**ADDENDUM NO.: One  
TO ALL OFFERORS:**

**REFERENCE:** Request for Proposal No: **RFP# FDC-1229**  
Dated: April 1, 2025  
Commodity: **Uninterruptible Power Supply (UPS) and Battery Maintenance**  
RFP Closing On: **April 30, 2025, at 2:00 p.m. (Eastern)**

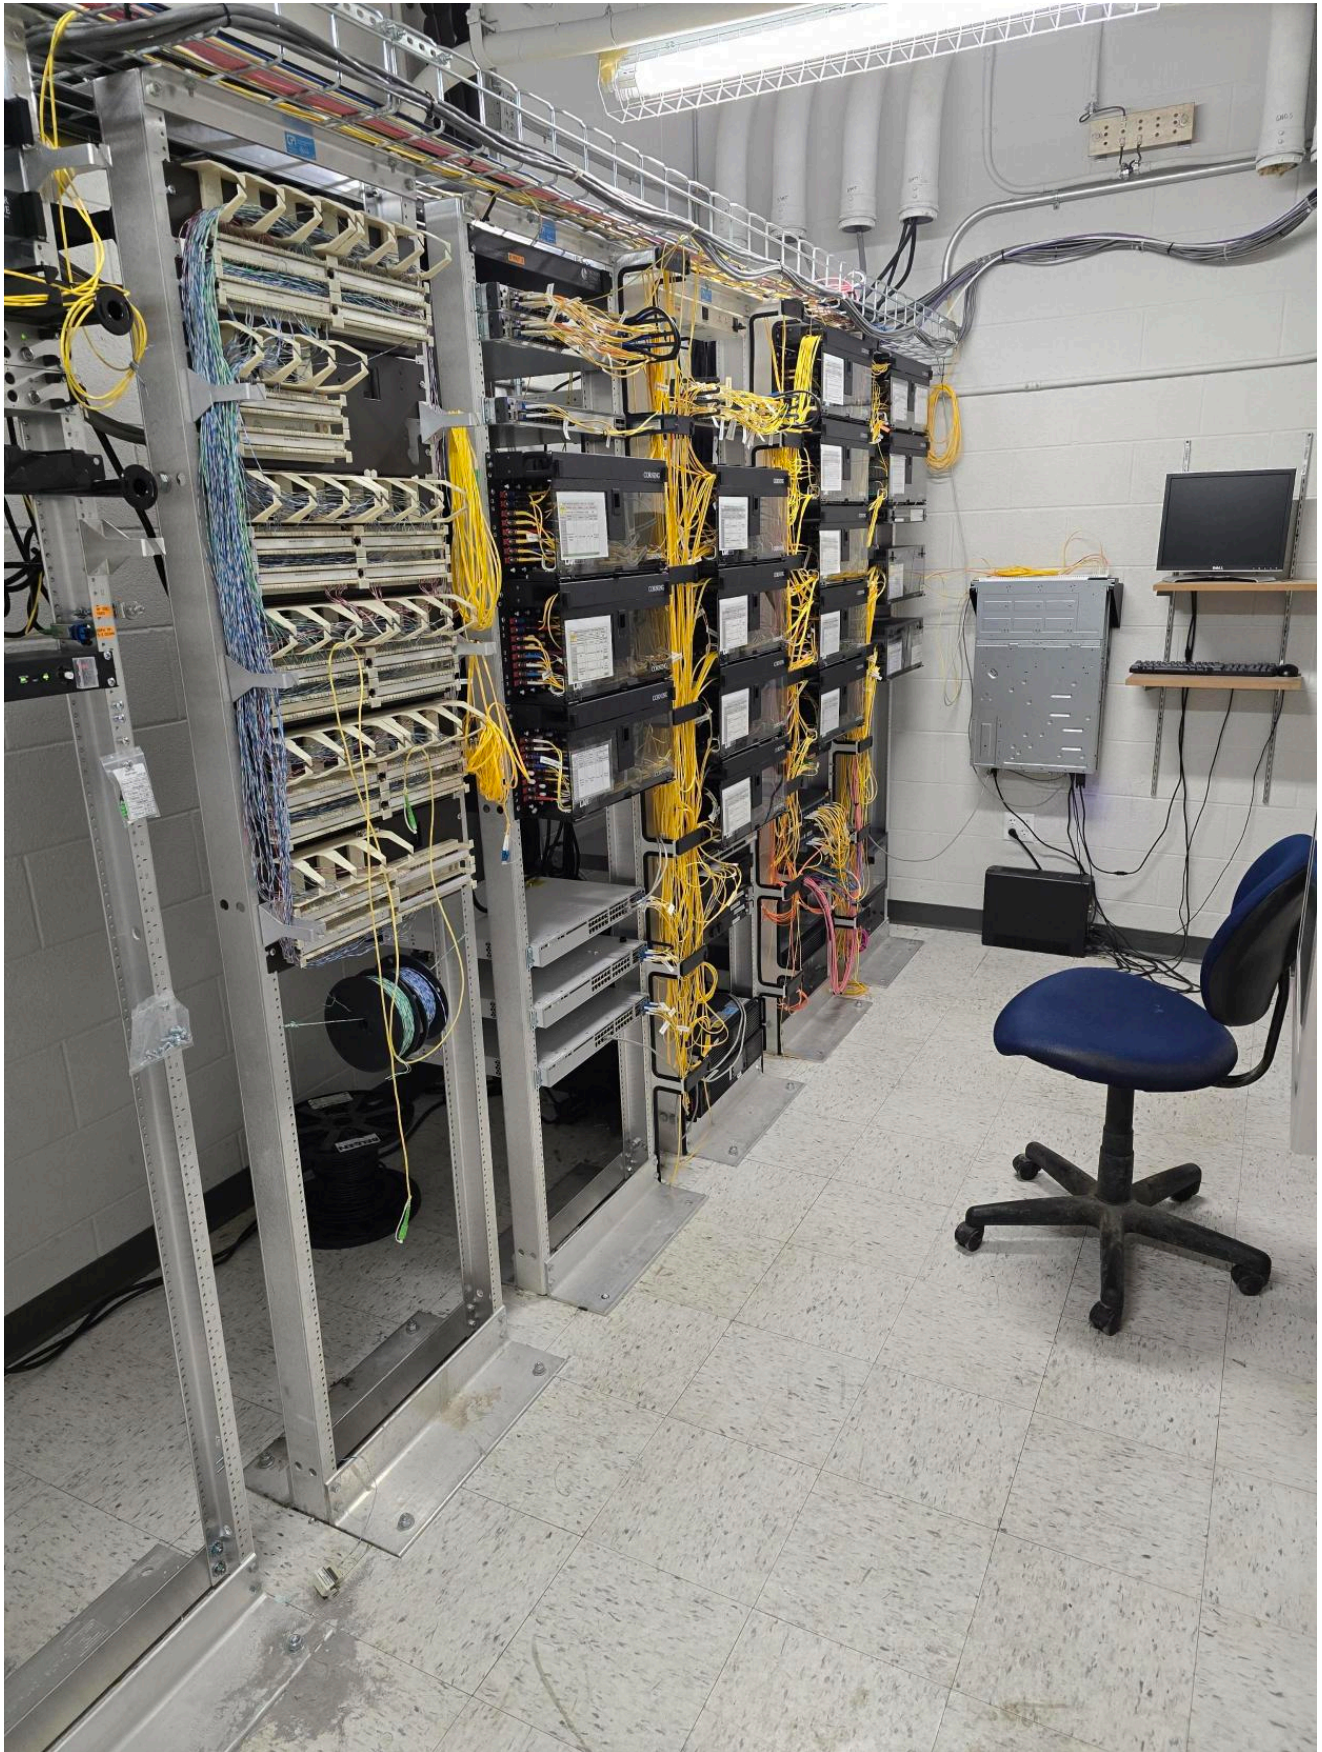
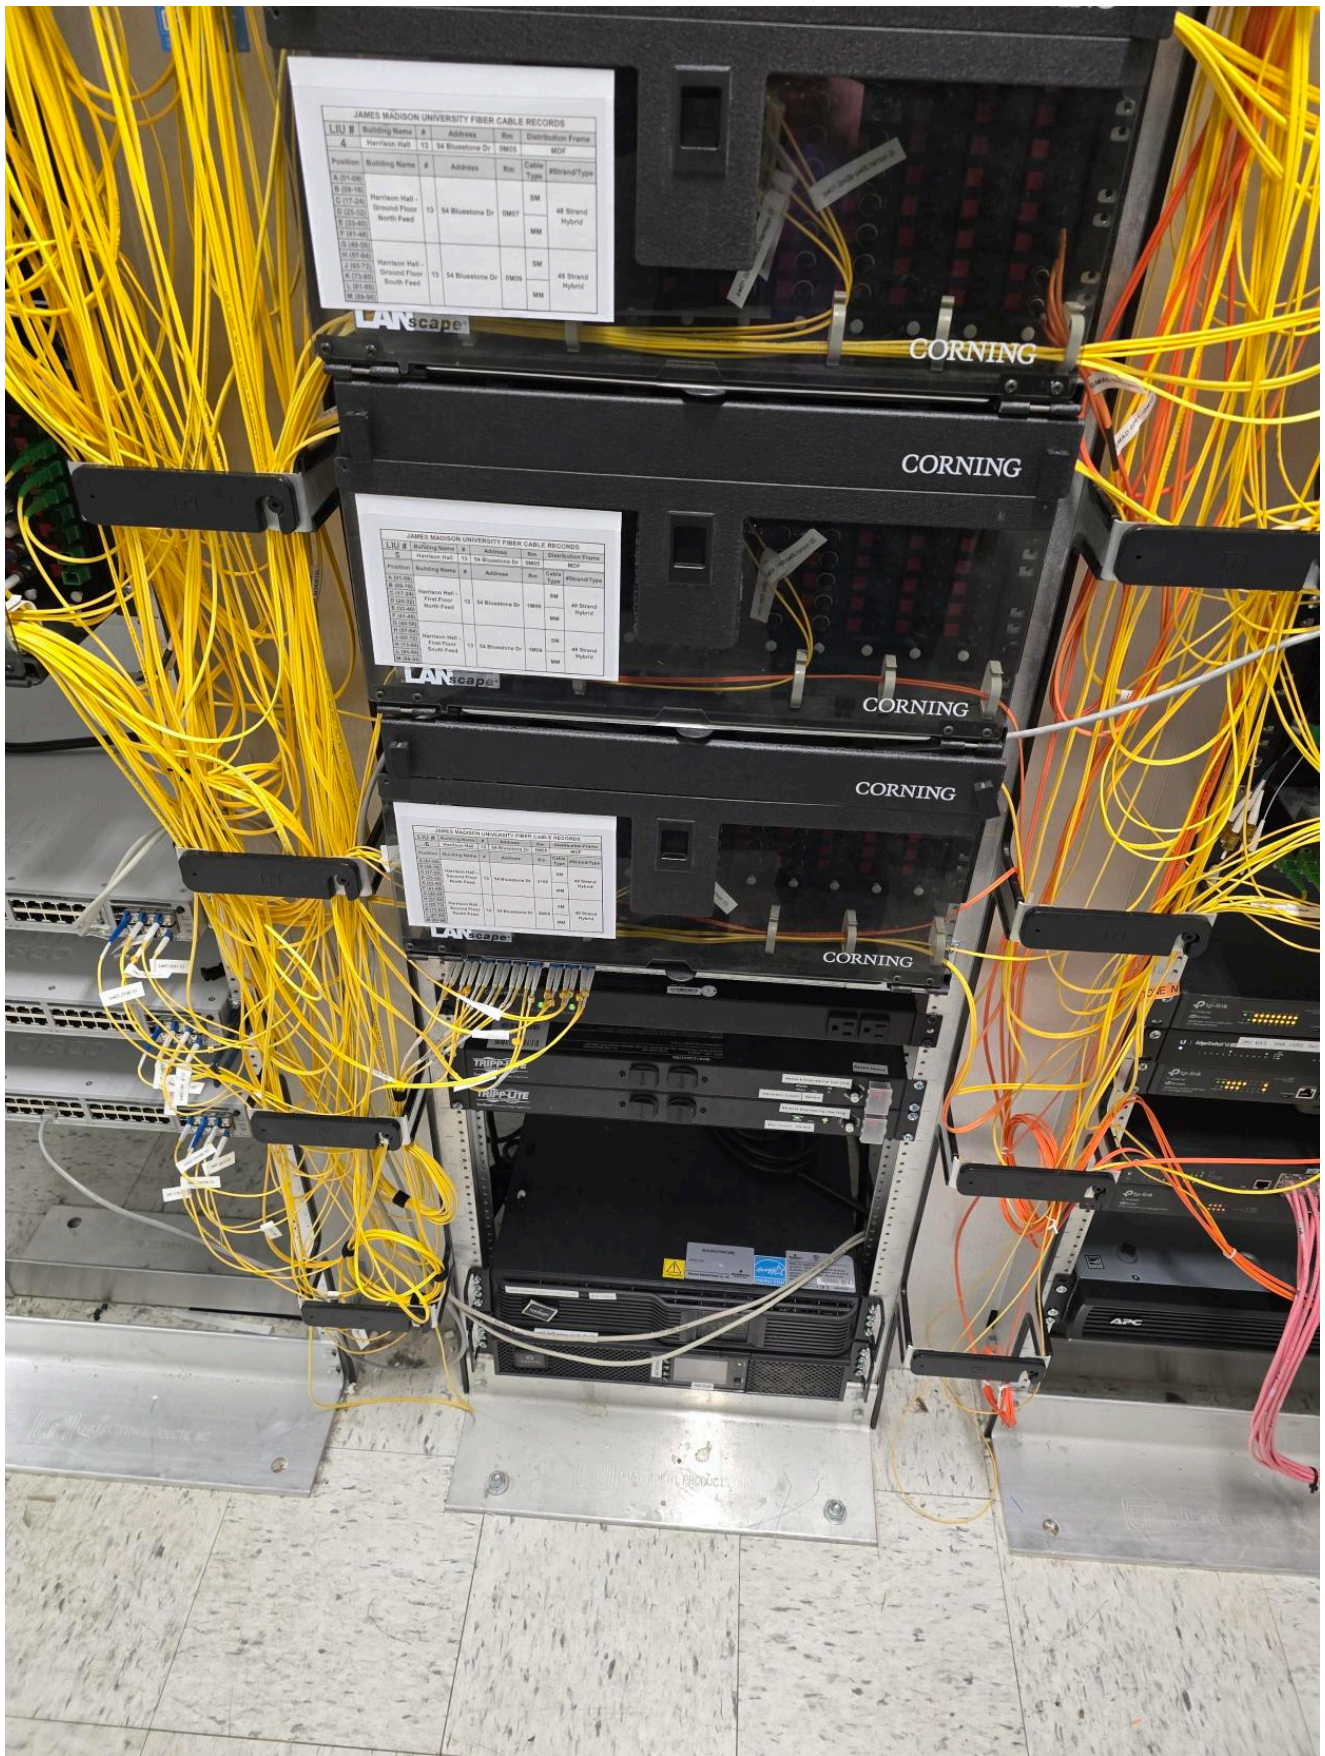
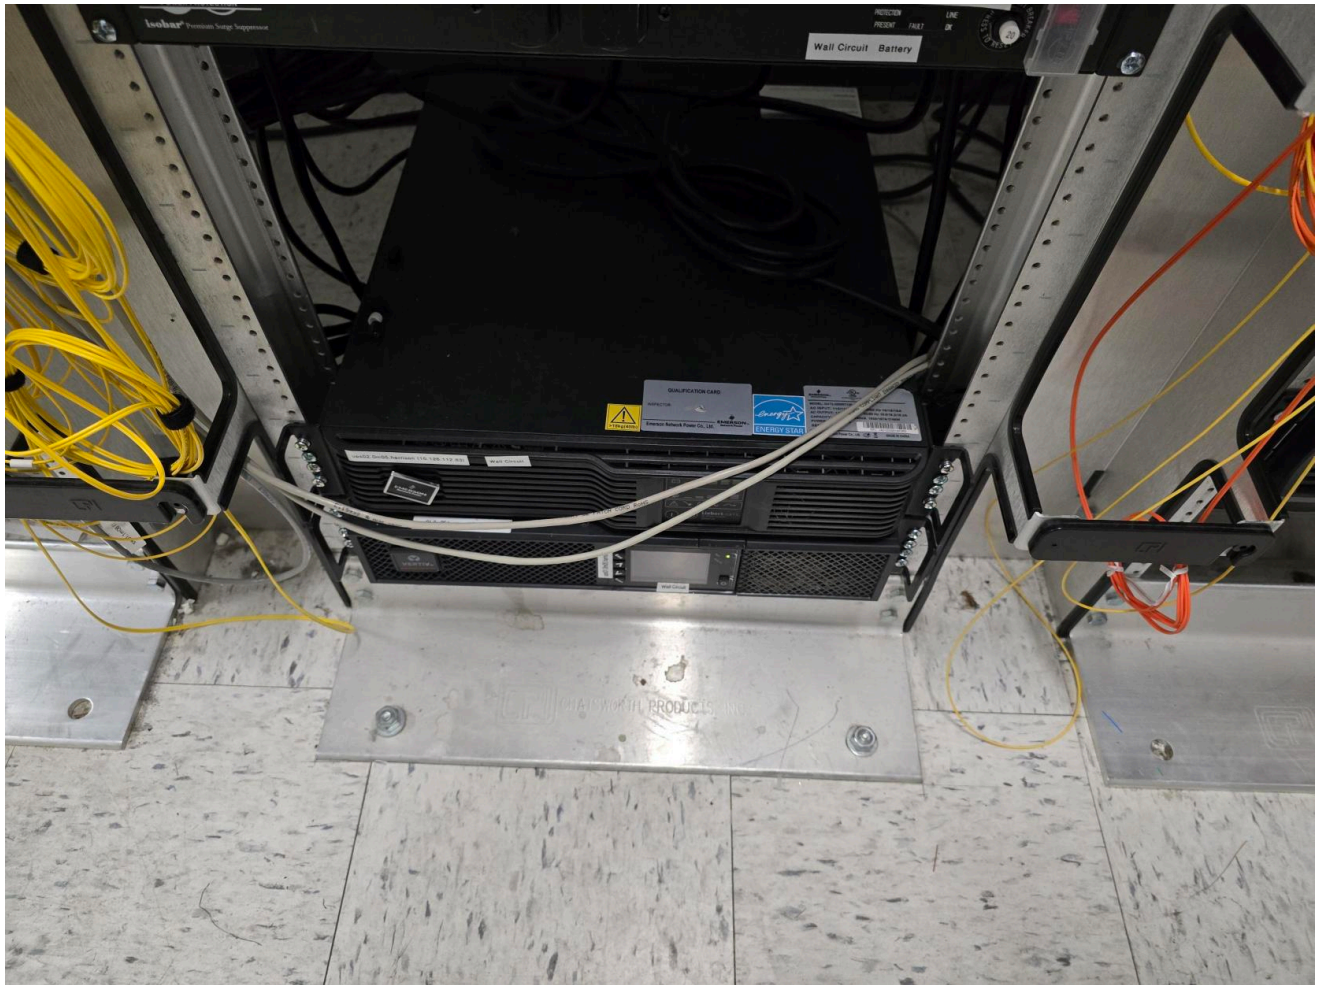
Question – Is an on-site visit possible prior to executing our response?

Answer – In lieu of a site visit, the following pictures are being provided.
